Responses to Requests for Supplemental Information to Support the TRISO-X License Application

**RESPONSES TO REQUESTS FOR SUPPLEMENTAL INFORMATION TO SUPPORT
THE TRISO-X LICENSE APPLICATION (Non-proprietary)**

Docket No. 70-7027; EPID: L-2022-NEW-0005

Geological Cross Sections Based on Soil Borings

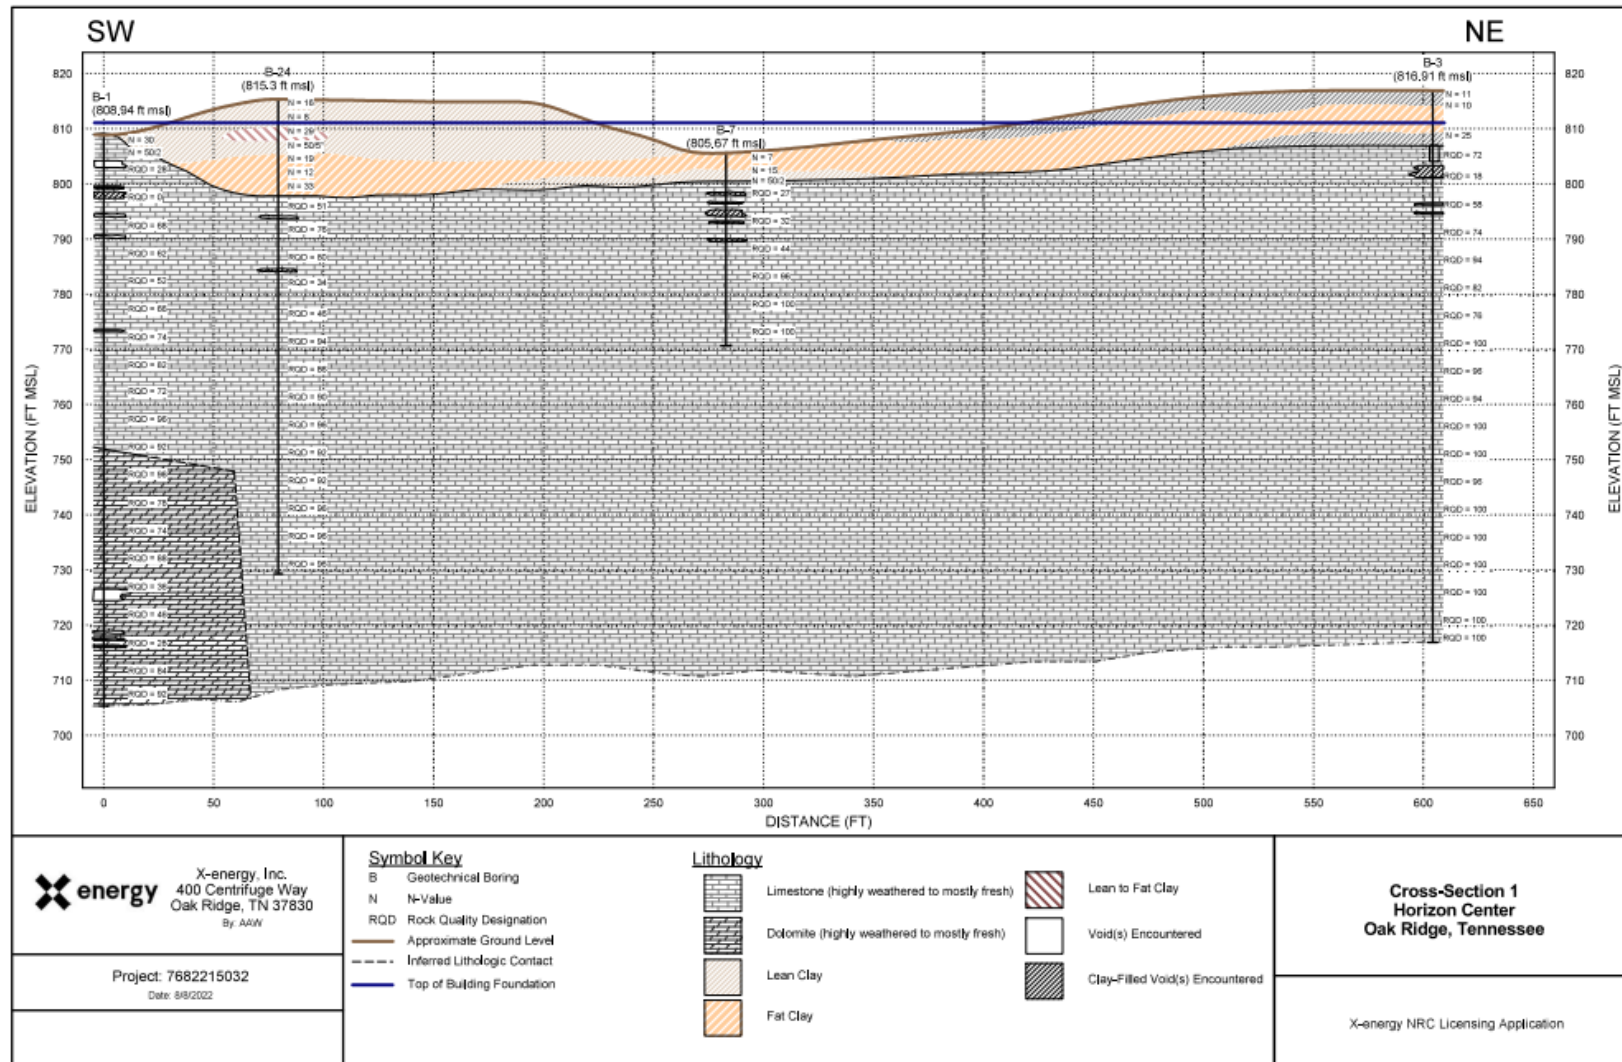
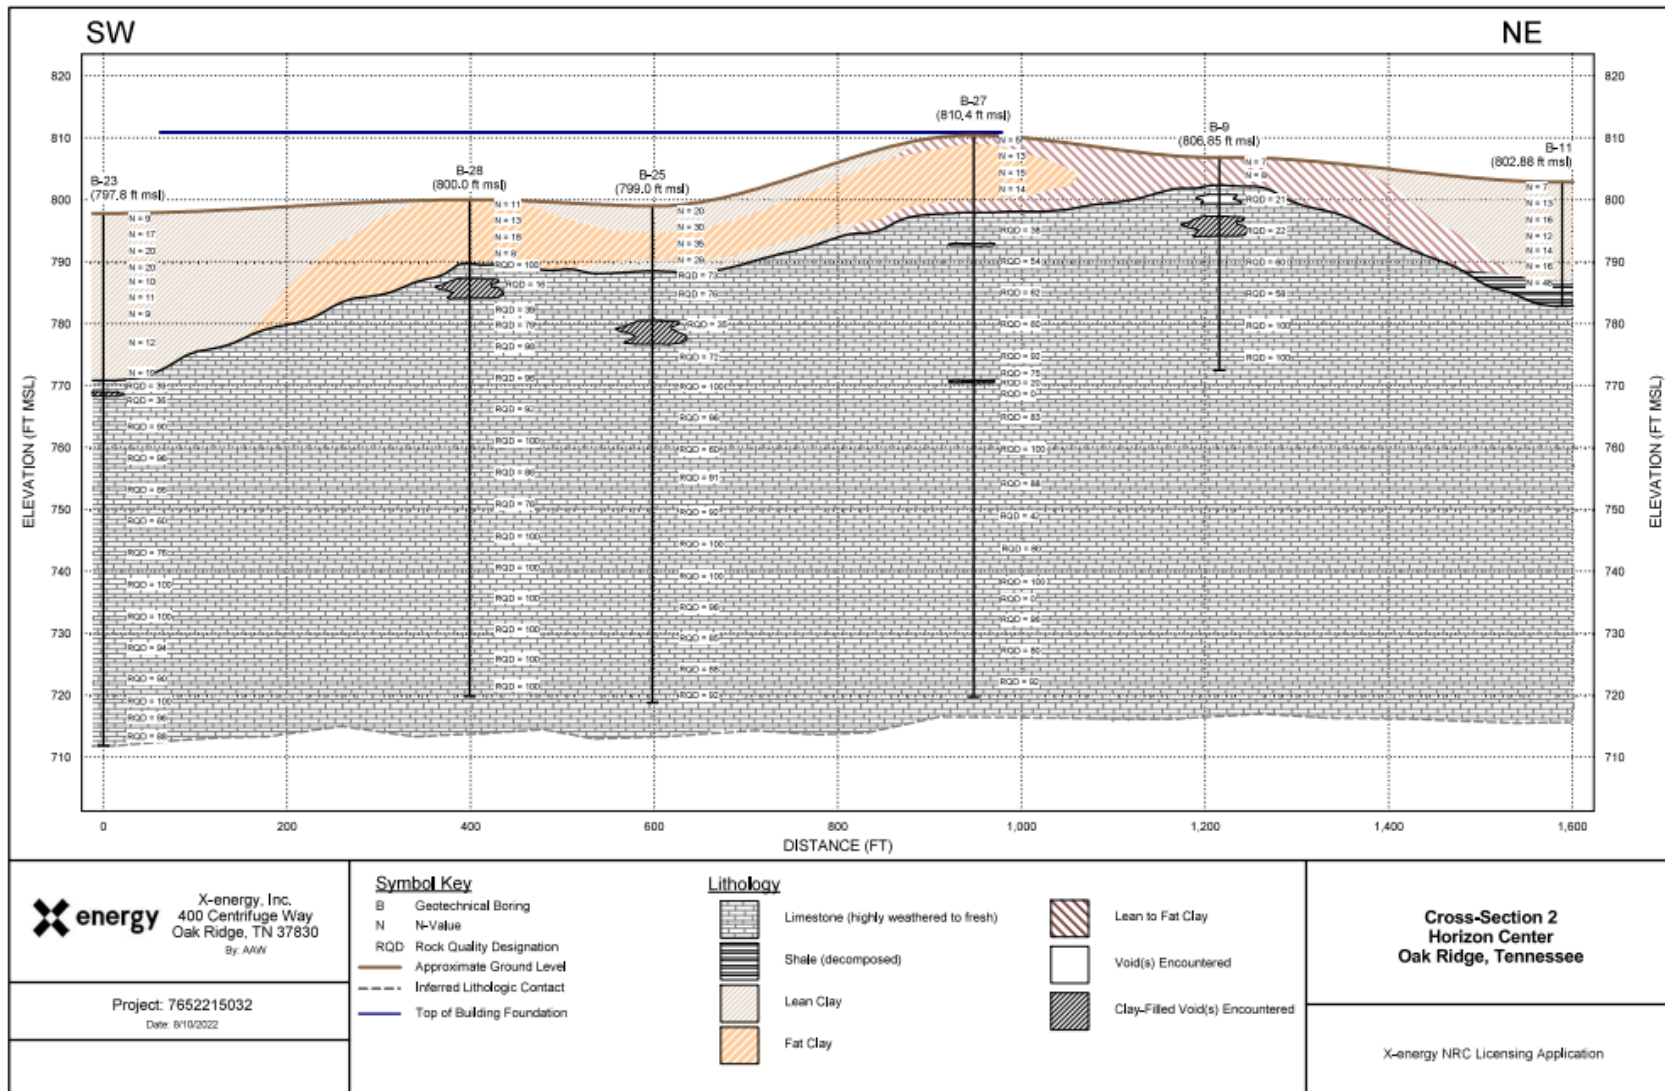
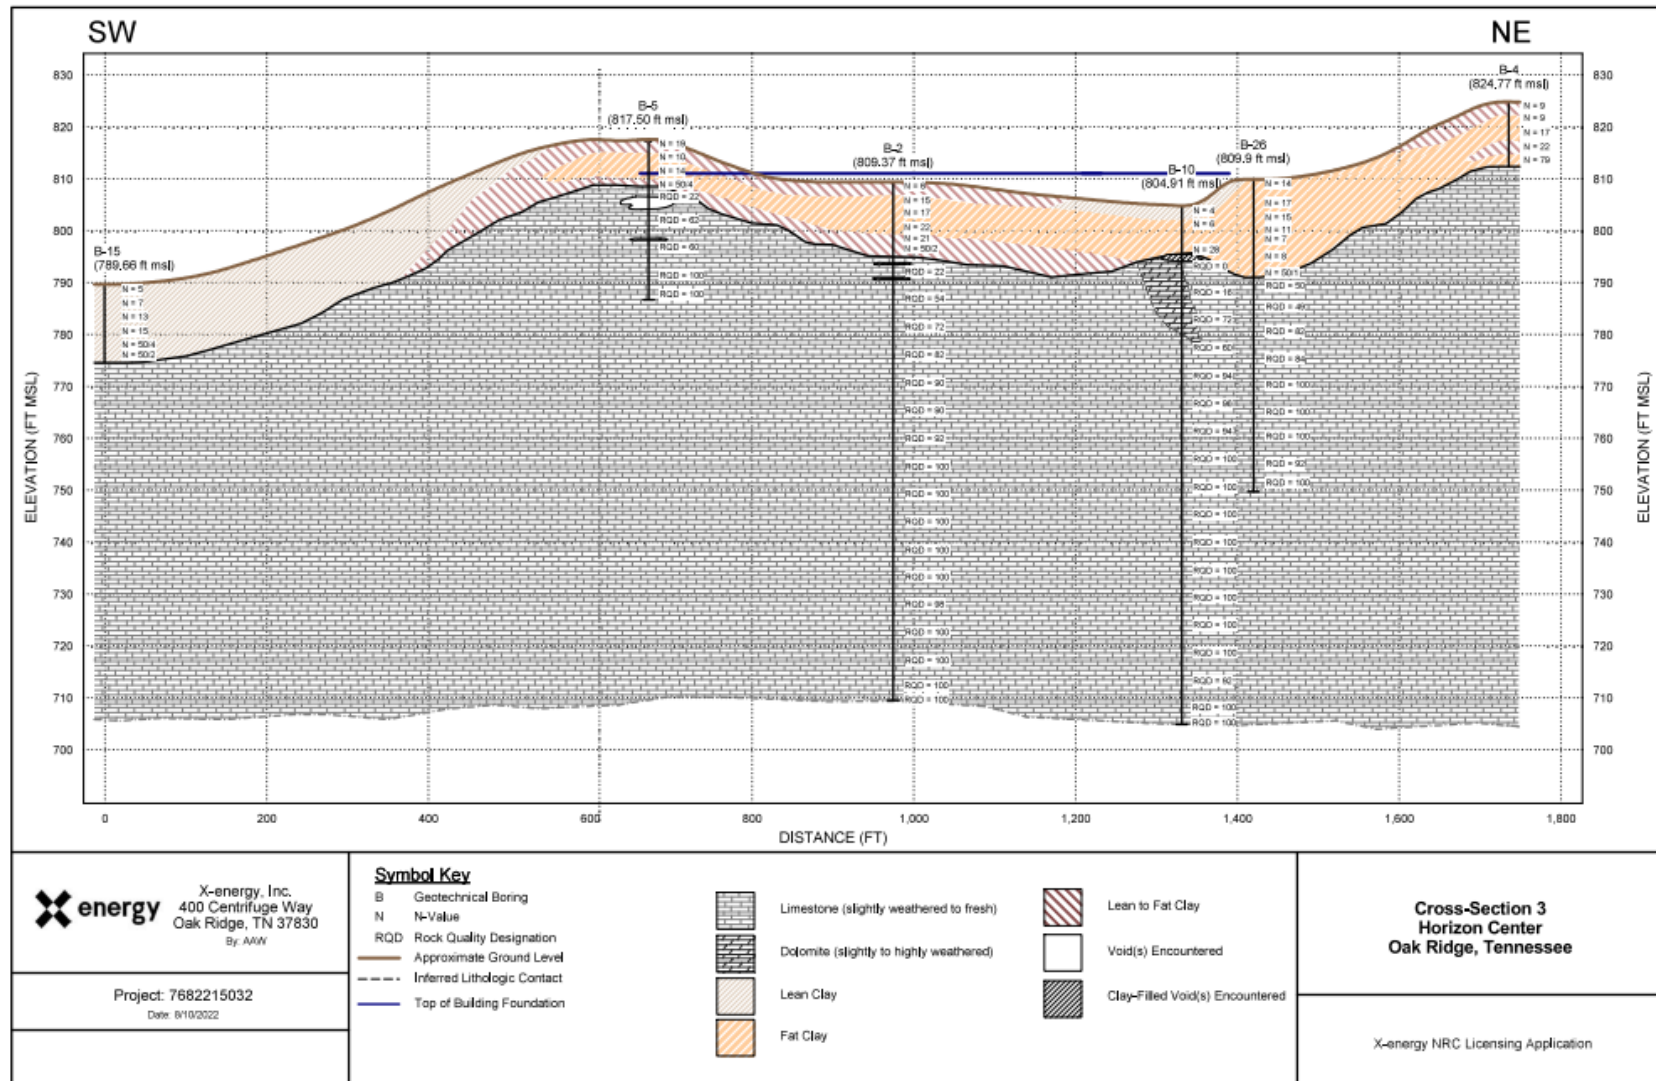
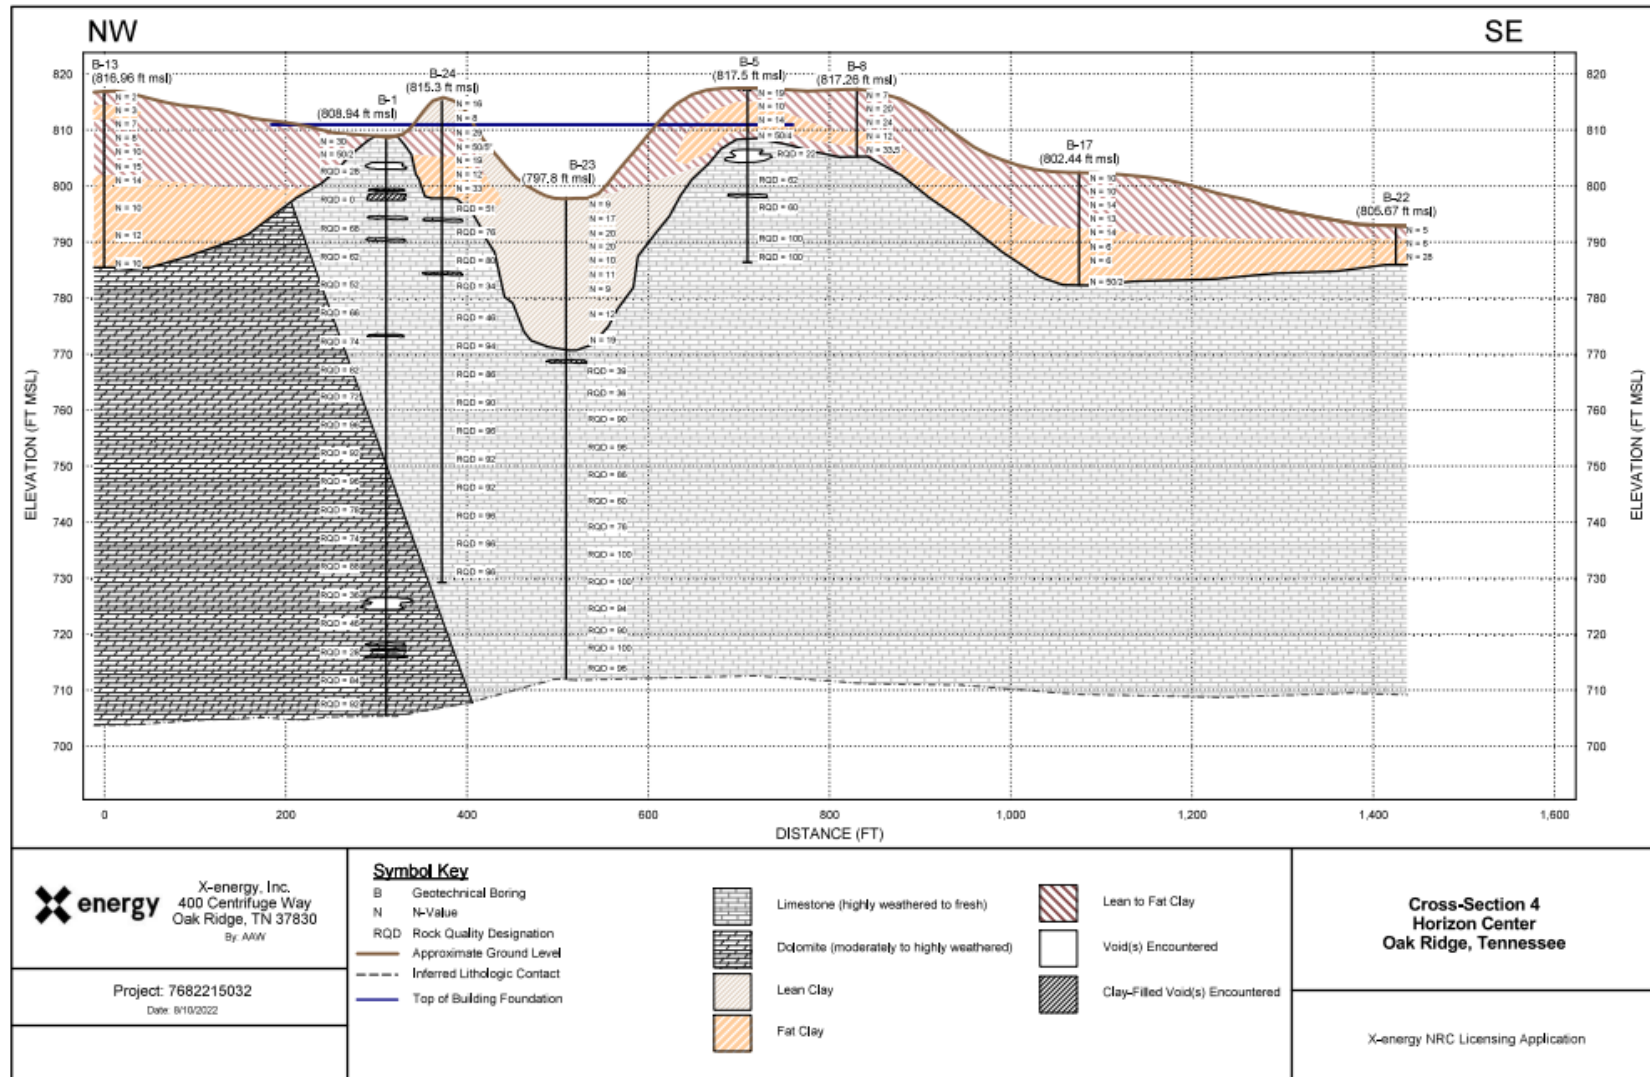
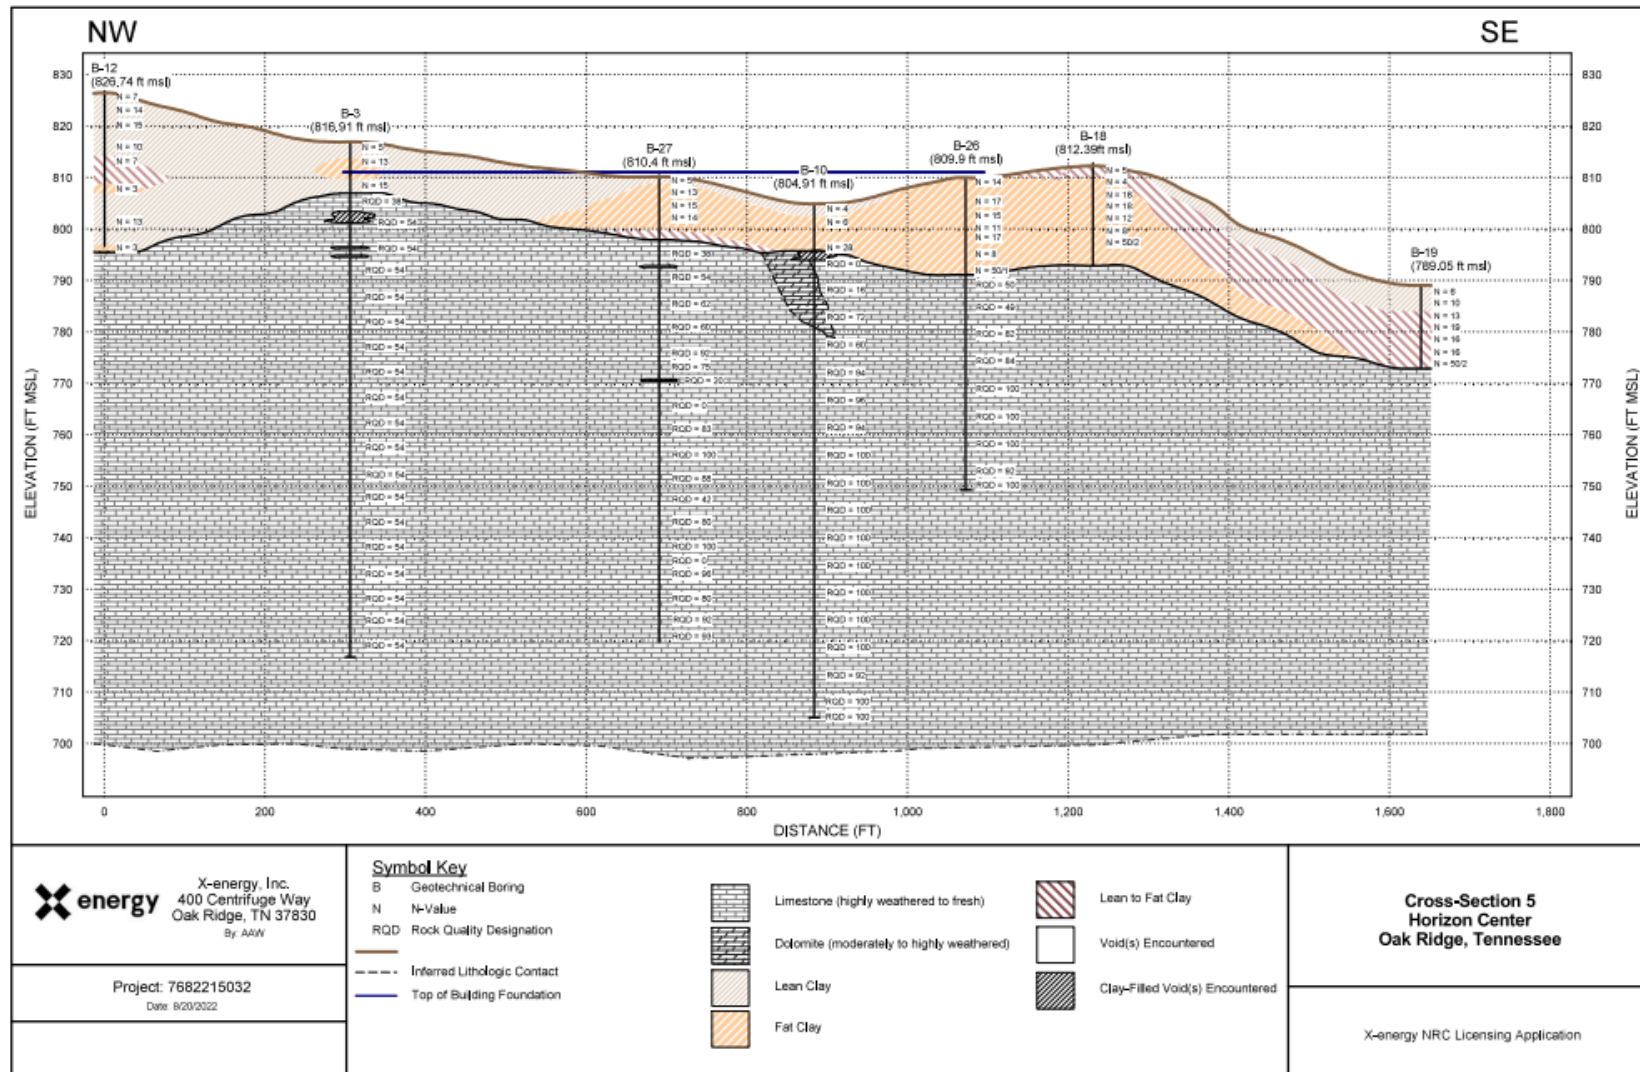
Provide information on engineering characteristics of the soil layer(s) and rock layers (e.g., dolomite and limestone) taken as bedrock. In addition, provide a geological cross-section of the site, developed based on the site geotechnical investigation. The plot should identify all the soil and rock layers encountered at the site. Additionally, the plot should also show the location of the proposed facility with respect to these geological units.

The soil layer over bedrock generally consists of medium stiff to very stiff CH and CL clay at depths ranging from 3.6 feet to 18 feet below the existing ground surface within the PB footprint. At a boring location to the south of the PB, the clay was encountered to a depth of 27 feet b.g.s. Based on the 12 geotechnical borings performed in the PB/AB area, the limestone and dolomite bedrock exhibit higher weathering at shallower depth (generally upper 10 feet to 20 feet) and became more competent at greater depths. The rock core recovery ranges from approximately 24% to 100% while Rock Quality Designation (RQD) ranges from 0 to 100%. The lower recovery and RQD were mostly within the upper rock layers. The unconfined compressive strength values of intact rock cores range from 4,500 psi to 19,500 psi, which indicates hard to very hard strength.

The cross sections of subsurface soil/rock profiles are provided in Attachment 2.

The License Application and ISA Summary will be updated to include this RSI response detail on Site Cross-Sections (includes the plots).
